Access Compliance Report

Public Rights-of-Way

(Curb Ramps)

Intersection ID: 10037212	Main Street: SANDY_ROCK_PL	Cross Street: N/A	Location: SW
ADA ID: 3824785B900A	Ramp Type: Perp	Initial Pass/Fail: Fail	Overall Compliance: No
Severity Score: 12.5			
Codes/Mitigation Info/Possible Solution		Field Measurements/Component Compliance

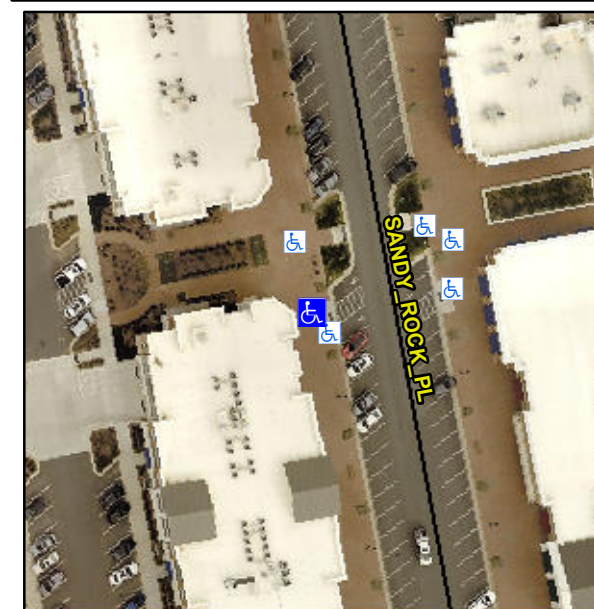
Not Found, R304.2.2

Compliance	Description	Data	Compliance	Description	Data
N/A	Ramp Length (in)	84.0	No	Ramp Slope (%)	9.6
Yes	Ramp Width (in)	59.0	Yes	Ramp XSlope (%)	1.9
N/A	Flare Type LT	N/A	N/A	Flare Type RT	N/A
N/A	Flare Slope LT (%)	N/A	N/A	Flare Slope RT (%)	N/A
N/A	Flare Traversable LT?	N/A	N/A	Flare Traversable RT?	N/A
N/A	Landing Length (in)	N/A	N/A	DWS Provided?	N/A
N/A	Landing Width (in)	N/A	N/A	DWS Contrast?	N/A
N/A	Landing Slope (%)	N/A	N/A	DWS Length (in)	N/A
N/A	Landing X Slope (%)	N/A	N/A	DWS Full Width?	N/A
N/A	Landing Curb? (Y/N)	N/A	N/A	DWS Offset (in)	N/A
N/A	Shared Landing?	N/A			
N/A	Gutter Ponding?	N/A	N/A	Gutter Slope (%)	N/A
N/A	Gutter Lip Ht (in)	N/A	N/A	Gutter X Slope (%)	N/A
N/A	Painted X Walk1?	No	N/A	Painted X Walk2?	N/A
	X Walk 1 Direction	To E		X Walk 2 Direction	N/A
N/A	X Walk 1 Width (in)	N/A	N/A	X Walk 2 Width (in)	N/A
	X Walk 1 Slope (%)	2.9		X Walk 2 Slope (%)	N/A
	X Walk 1 X Slope (%)	1.2		X Walk 2 X Slope (%)	N/A

Remove & Replace Entire Ramp.
